# PRE-BID CLARIFICATION FORM

PROJECT NAME:	FILLMORE HIGH SCHOOL NEW ATHLETIC COMPLEX		
PROJECT NUMBER:	Project No. 2024-017 / DSA #03-123950		
TO:	RJ Stump Fillmore Unified School Dist.  Roy Frey WestGroup Designs		
	EMAIL: <a href="mailto:ri.stump@fillmoreusd.org">ri.stump@fillmoreusd.org</a> ,  EMAIL: <a href="mailto:royfawest2roupdesigns.com">royfawest2roupdesigns.com</a>		
DATE:	5-Feb		
FROM:	SC Anderson - Raymond Ramos	EMAIL:	<a href="mailto:estimating@scanderson.com">estimating@scanderson.com</a> ; <a href="mailto:jramosr@scanderson.com">jramosr@scanderson.com</a> ; <a href="mailto:joejannino@scanderson.com">joejannino@scanderson.com</a>
DOCUMENT/DIVISION NUMBER:	Spec Section 2.1.4.4 Other Utilities	DRAWING NUMBER:	N/A

## SITEMAP RECORD EXHIBIT

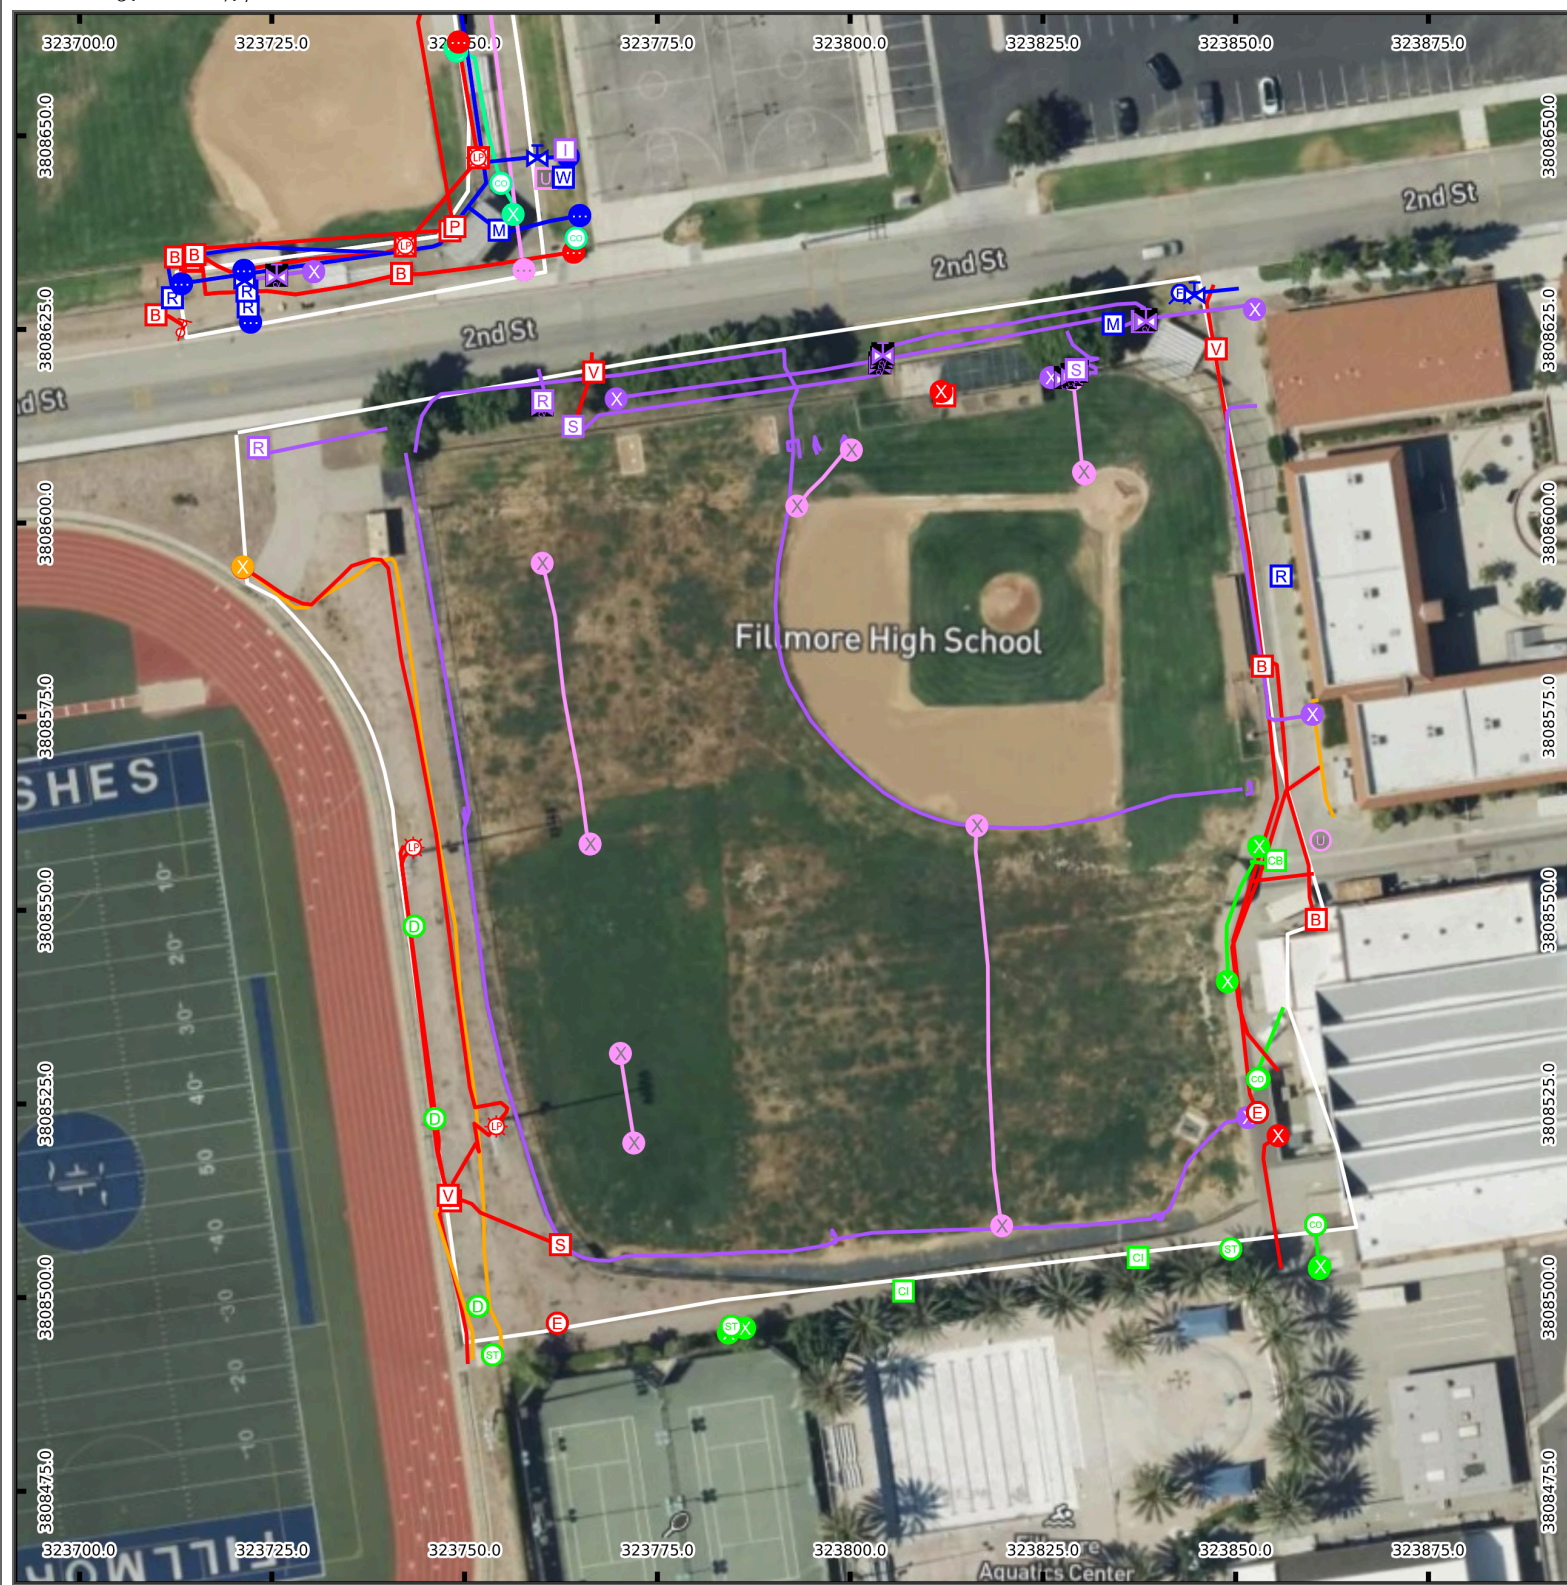
General condition states should it be necessary to remove, relocate, or temporarily maintain a utility because of interference with the work, the general contractor is to include this cost if not covered by utility owner.

Please confirm this excludes any unforeseen utilities, not referenced on drawings.

If bidders are to include any unforeseen utilities, please provide an allowance to be included in all bids.

Prime contractor is not responsible for undocumented utilities. In addition to the utilities shown on the plans, the District will provide a Utility scan prior to construction. Contractor will be responsible for verifying and potholing all known or identified utilities.

Attached is a preliminary utility scan for existing utilities.
